I-295 Southbound, Falmouth-South Portland

Bridge Joint Rehabilitation Information

Contract Modification

Reconstruct 2 Type 5 bridge joints on Fore-River Bridge

SUBJECT FORE RIVER BRIDGE JOINT MOD

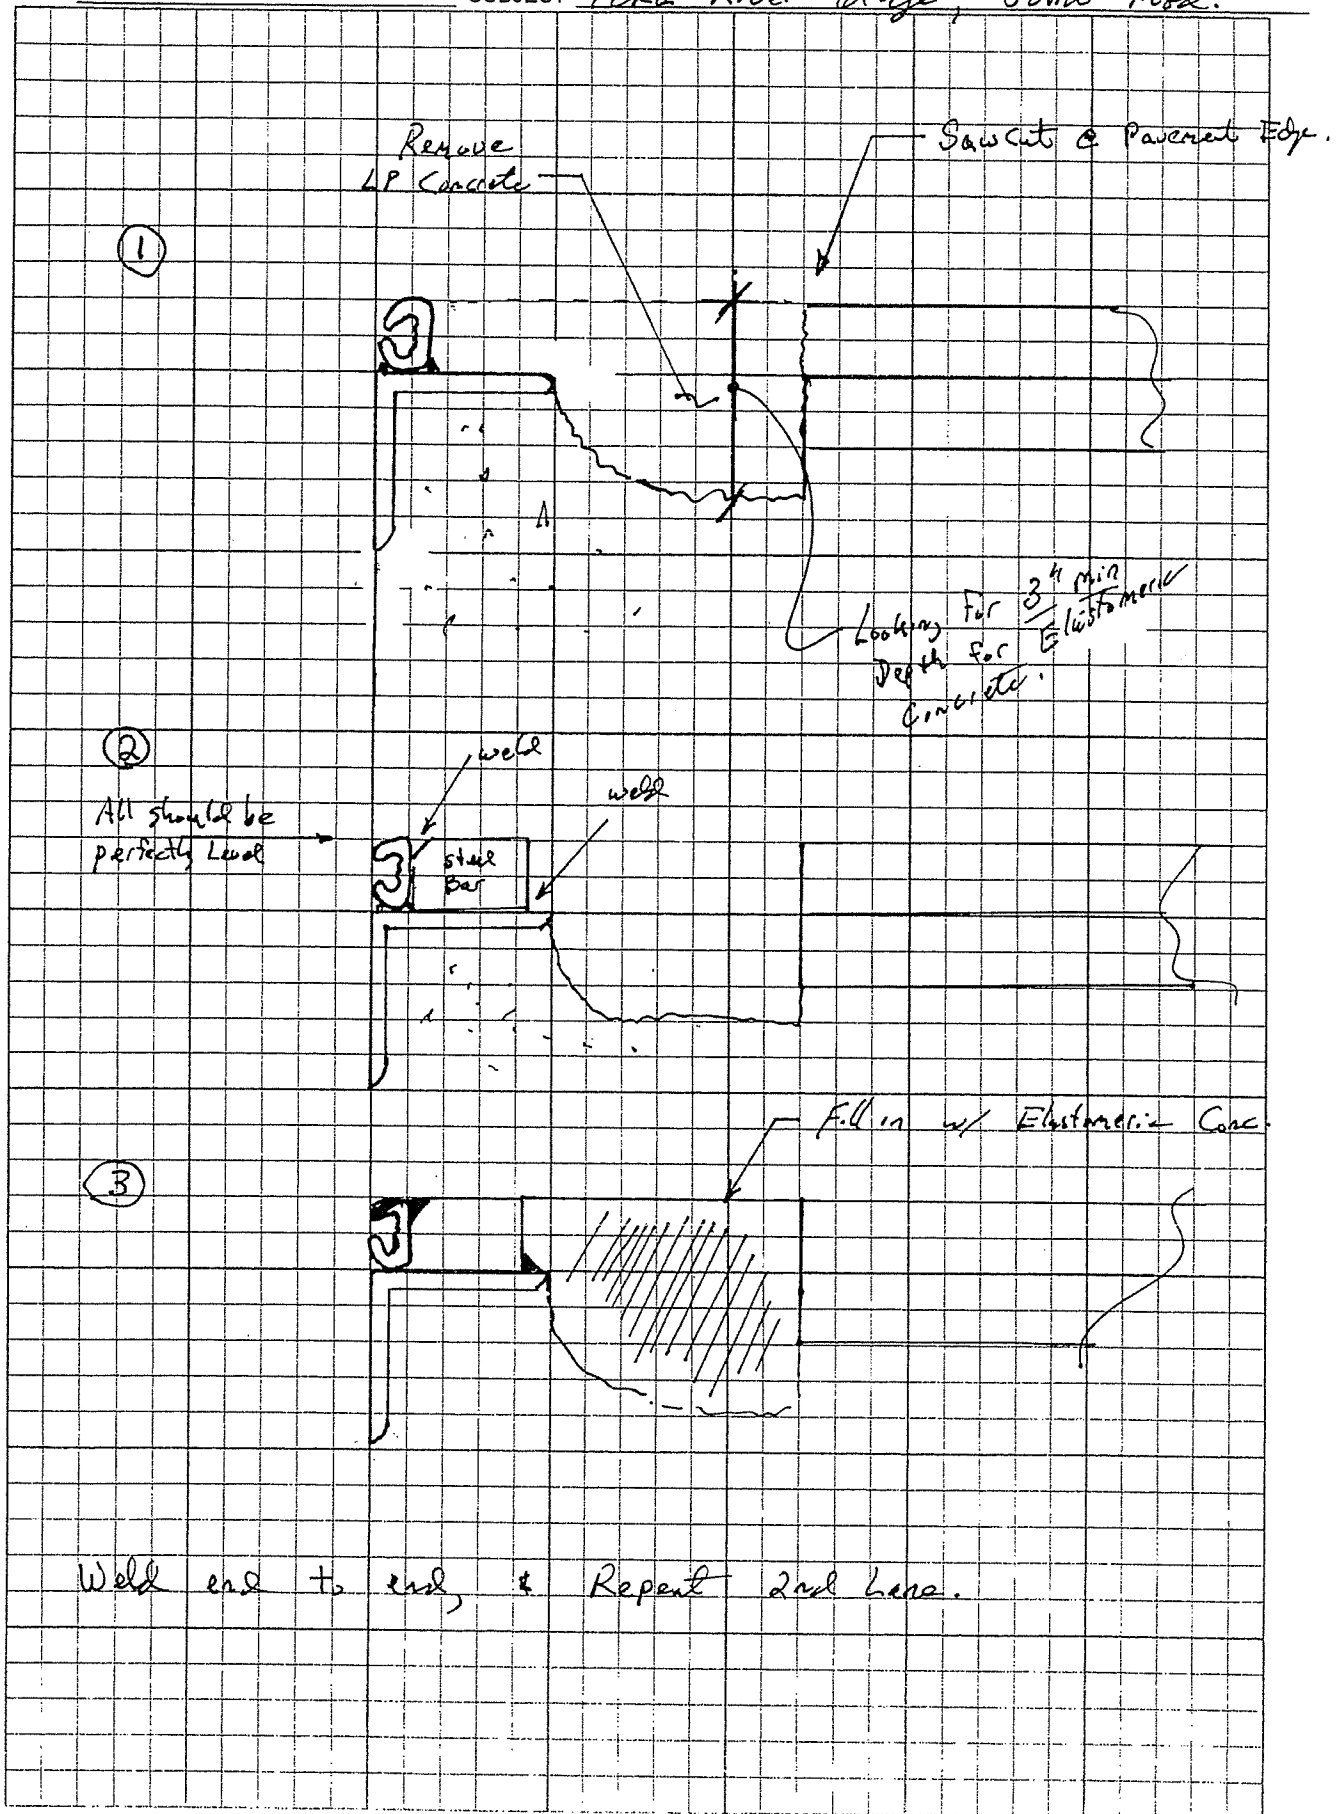
Reconstruct both of the type 5 bridge joints on the Fore River bridge according to sketches by Bill Doukas dated 1/11/10 (1/11/11?). This work provides and installs all of the labor, material and equipment needed to complete the work shown on the sketches. All of the quality requirements of the joints installed under the original bid also apply to this contract modification.

Reason: The joints installed under the original bid documents have a design flaw that causes the concrete at the joint to crack. This will replace that area of concrete. This item will be used for the reconstruction performed in 2011.

INTERSTATE 295 SOUTHBOUND
PTRR (ST. JOHN)
PORTLAND CUMBERLAND COUNTY
PLAN AND TRANS. SECTION

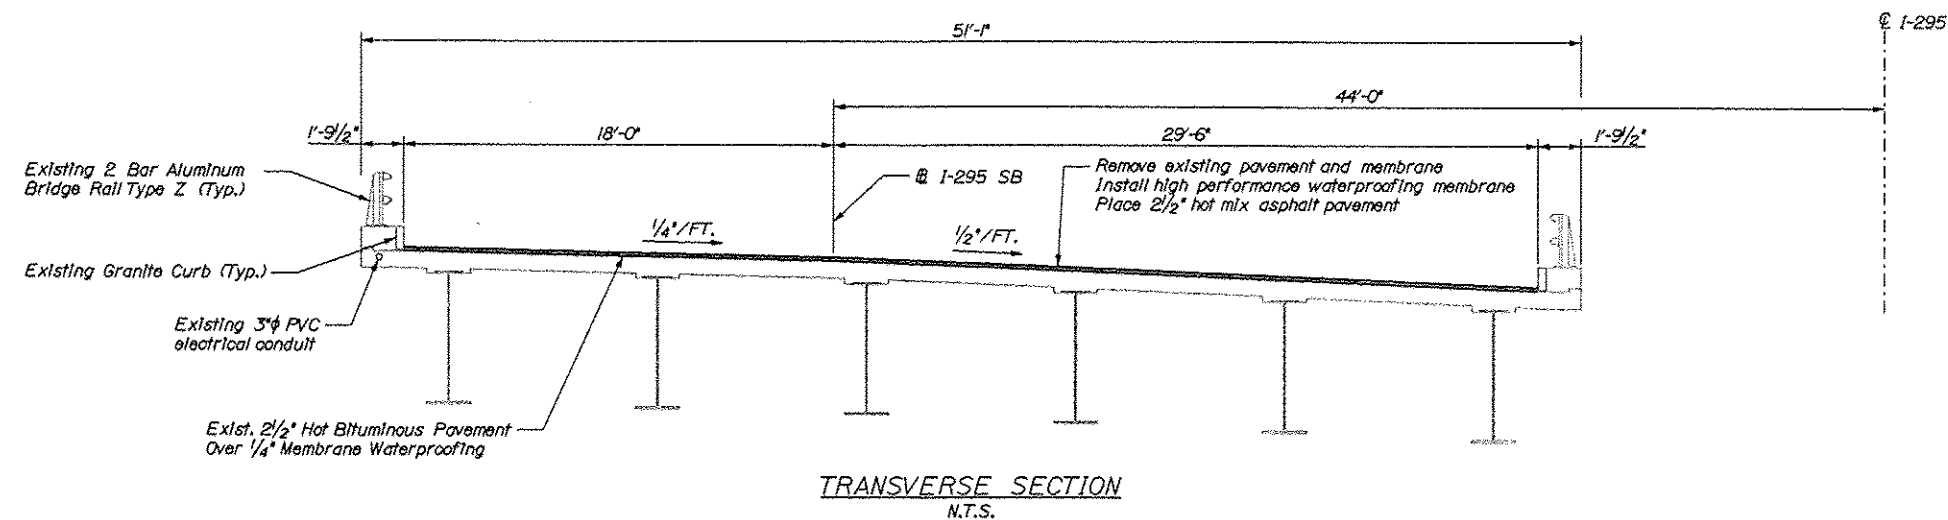
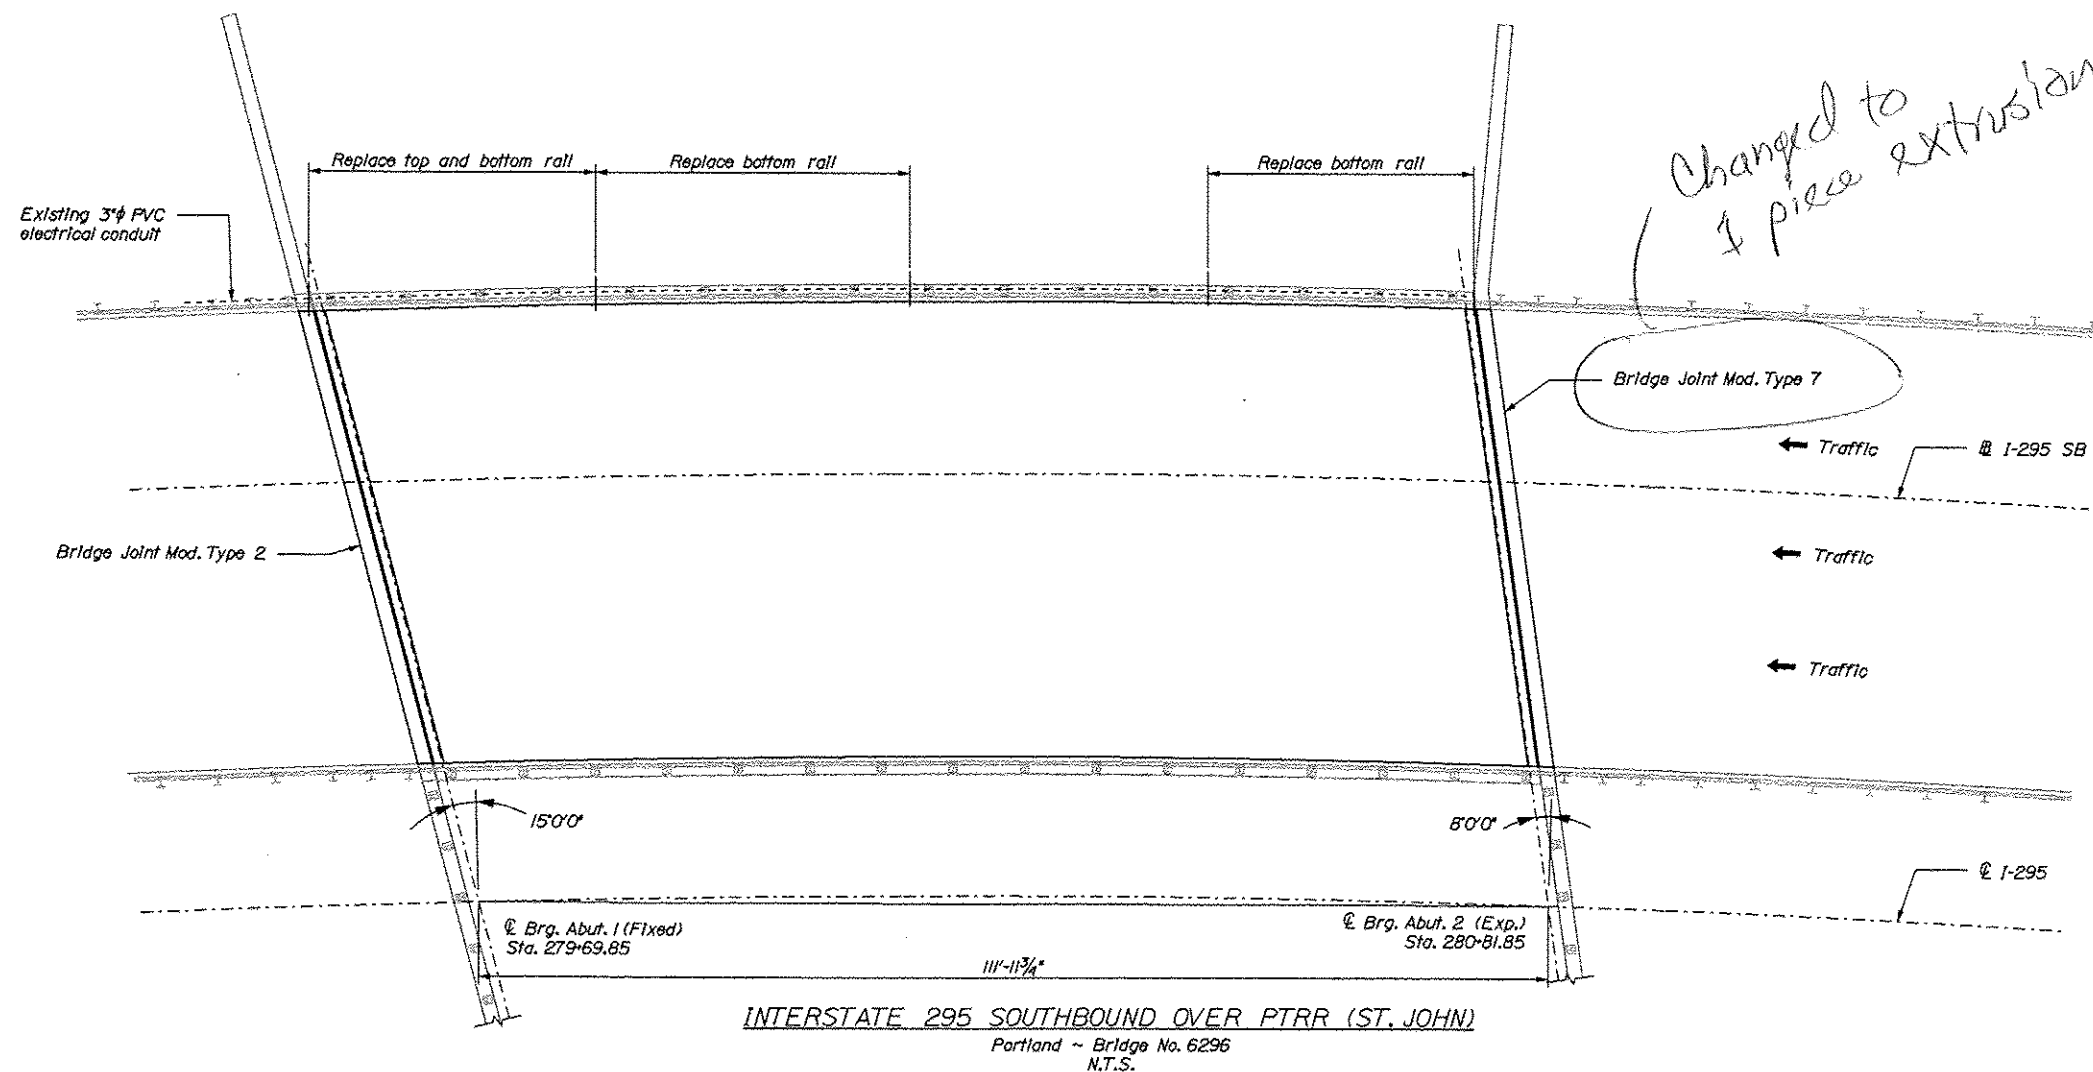
/ Changed to 1 piece extrusion
